PD Modification Application: MM 23-0407
Zoning Hearing Master Date: October 16, 2023
BOCC Land Use Meeting Date: December 12, 2023

AGENCY REVIEW COMMENT SHEET

DATE: 10/04/2023
AGENCY/DEPT: Transportation
PETITION NO: MM 23-0407

Re: **DESIGN EXCEPTION FOR
PAULS DRIVE – MODIFIED TS-03 TYPICAL SECTION
CASE NUMBER: MM 23-0407
FOLIO # 071593-0100**

8.1 Approved Site Plan (Full)

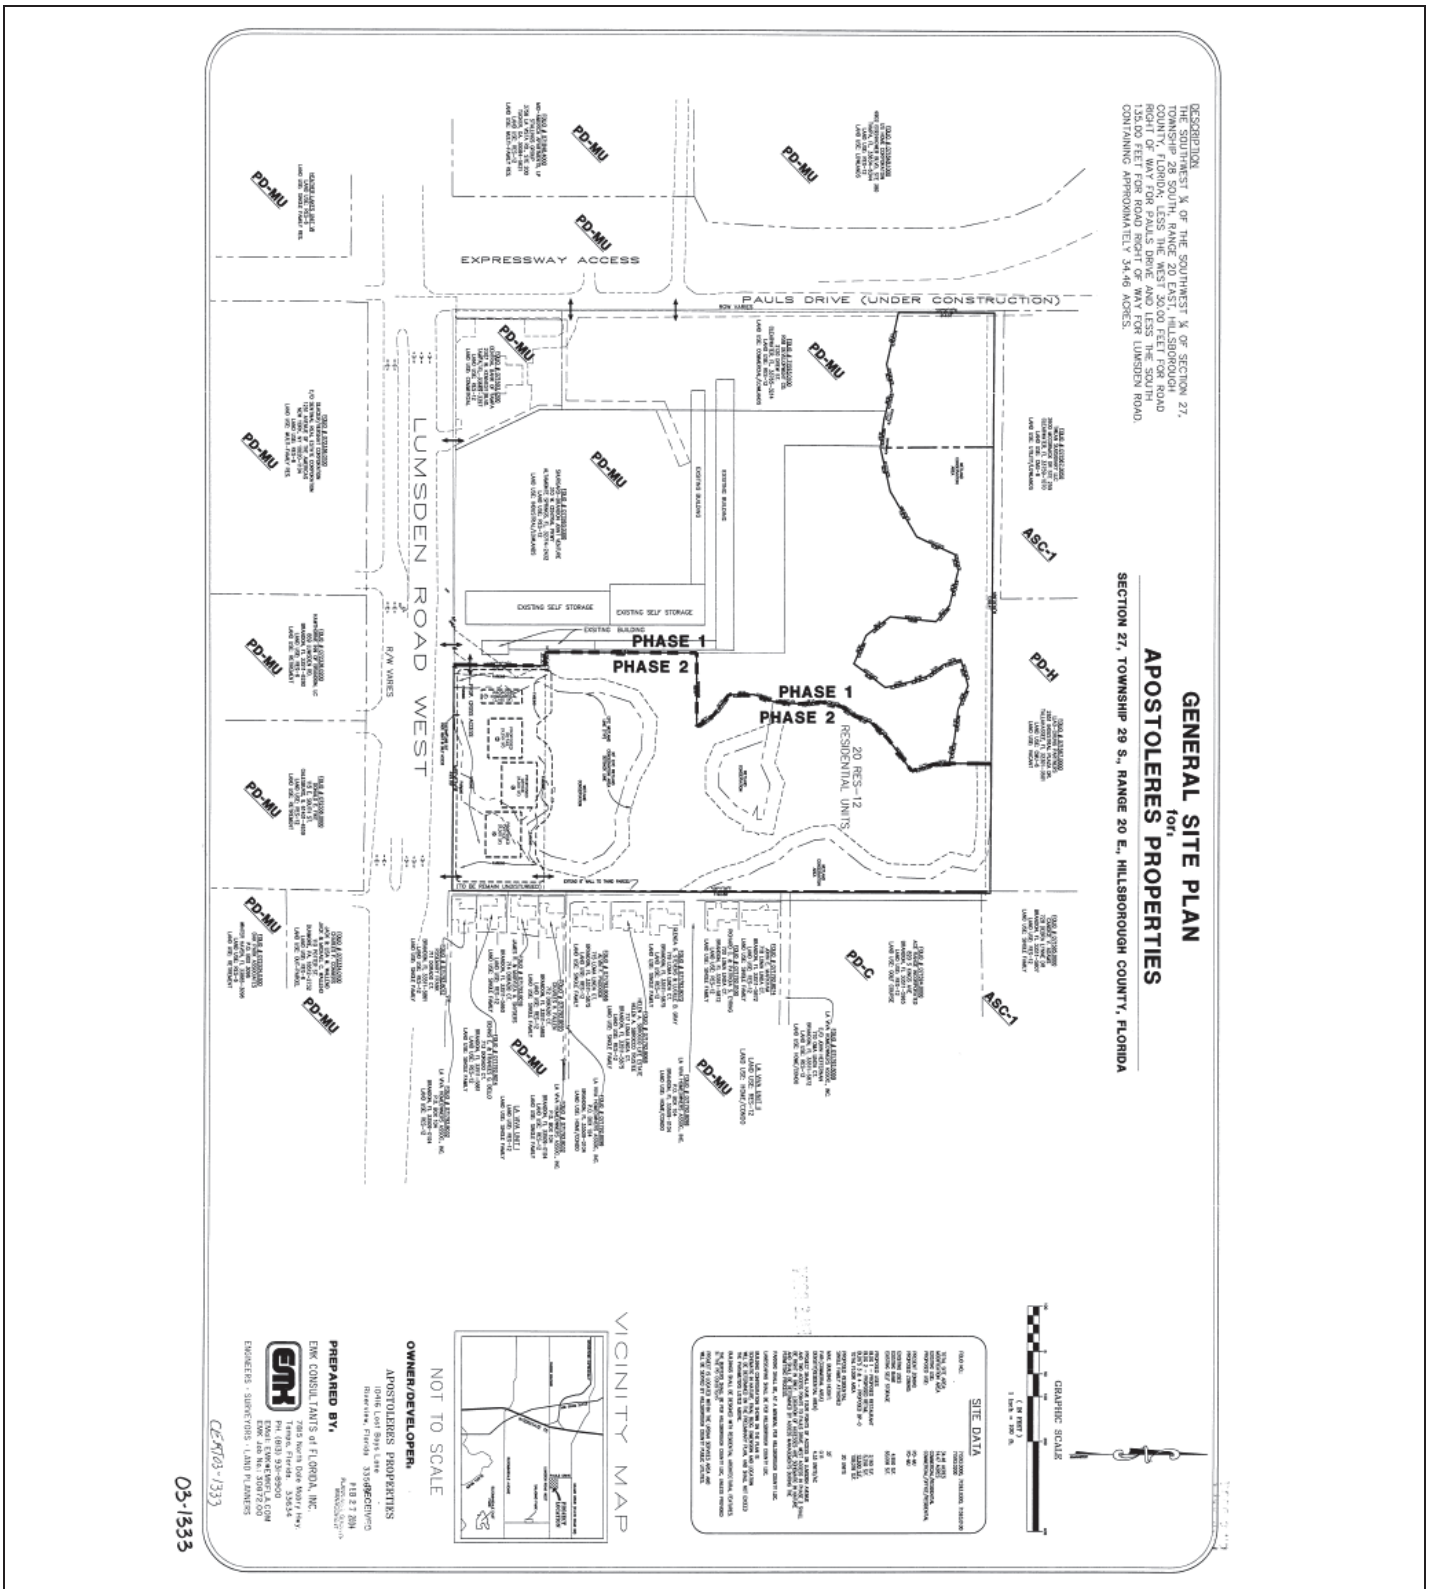
Prior to PD site plan certification, the applicant shall revise the PD site plan to:

1. Remove existing mini-warehouse square footage in Phase 1.
2. Replicate Phase 2 as shown in 03-1333.

APPENDIX B: Pauls Drive Typical Section – Modified TS-03

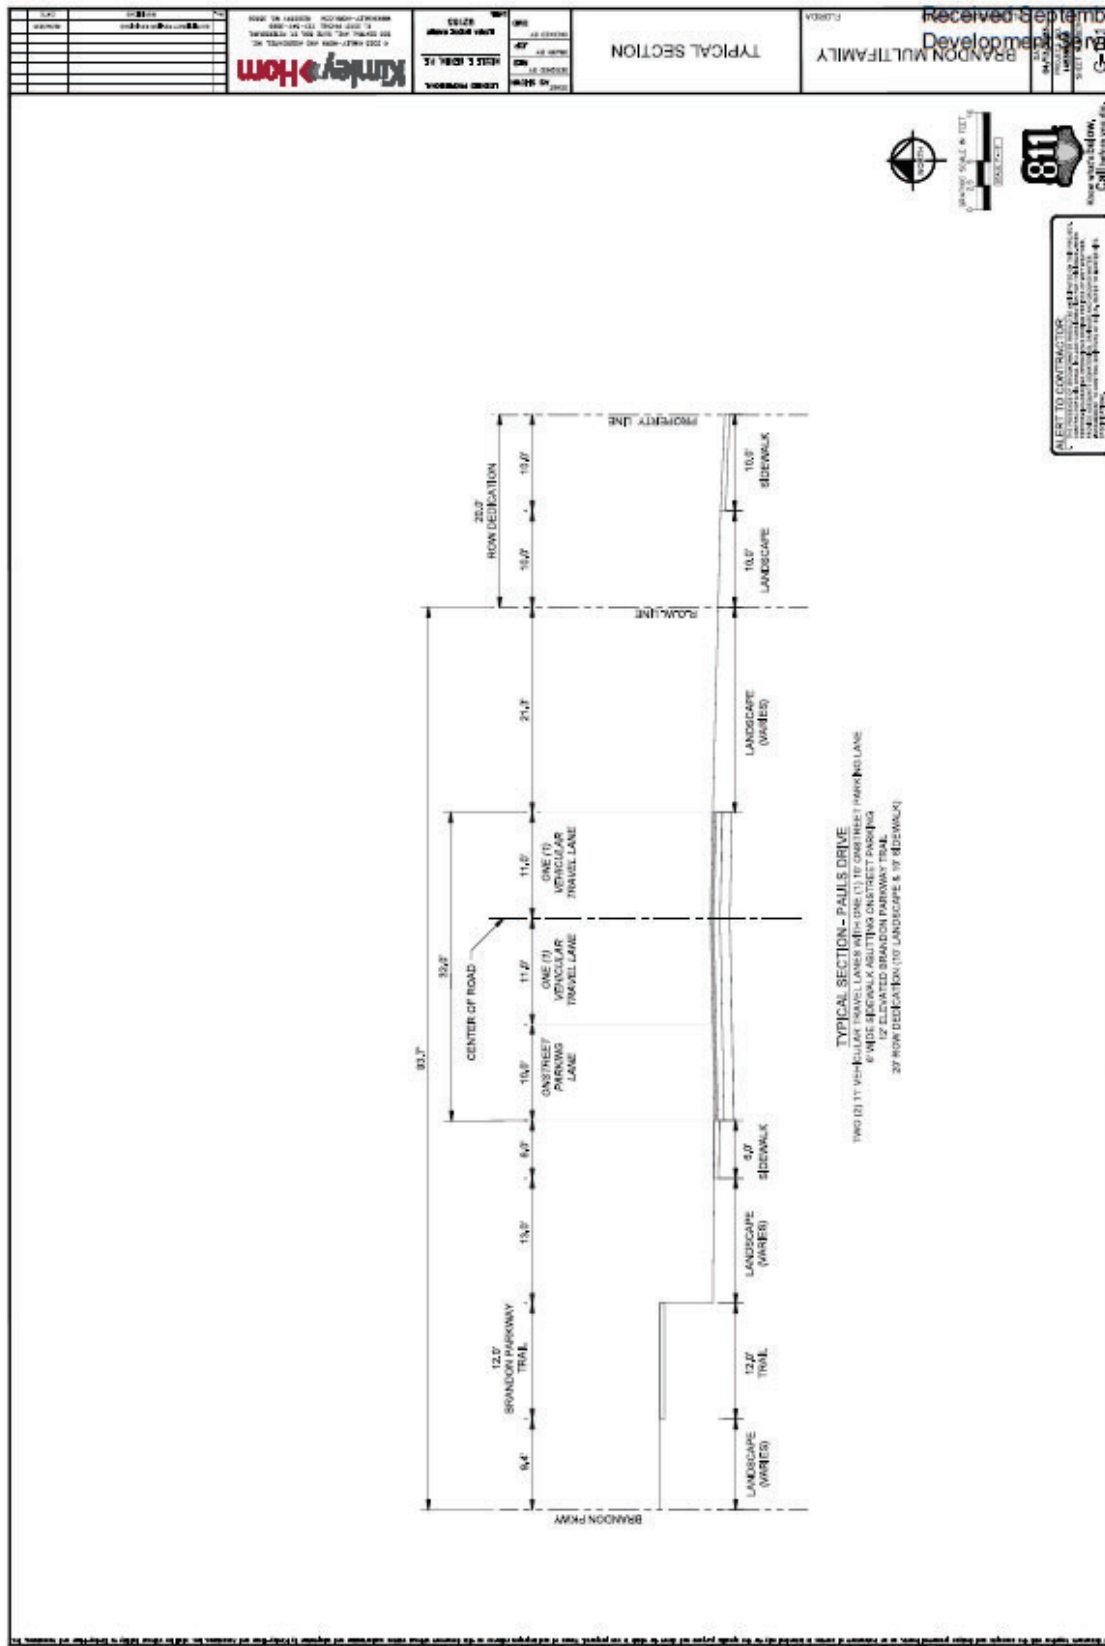
Due to the presence of the Brandon Parkway Trail and its associated parking to the west, expansion of Pauls Drive to conform with the Hillsborough County TTM Typical Section TS-03 (Local Urban Road) would have to occur to the east, which cannot occur without significant impacts to the existing wetlands. The following modifications to the TS-03 typical section are requested:

the road. An additional 20-feet of right-of-way will be dedicated to Pauls Drive, and a 10-foot wide sidewalk in line with the Brandon Community Plan Urban General district. The developer is committed to build one (1) pedestrian mid-block crossing per Hillsborough County standards and specifications to provide pedestrians safe access to the Brandon Parkway Trail, the location of which will be coordinated and approved by the Public Works Department during site permitting. The proposed modified TS-03 typical section is provided in **Appendix B**.

If this zoning is approved, the County Engineer will approve the Design Exception request.
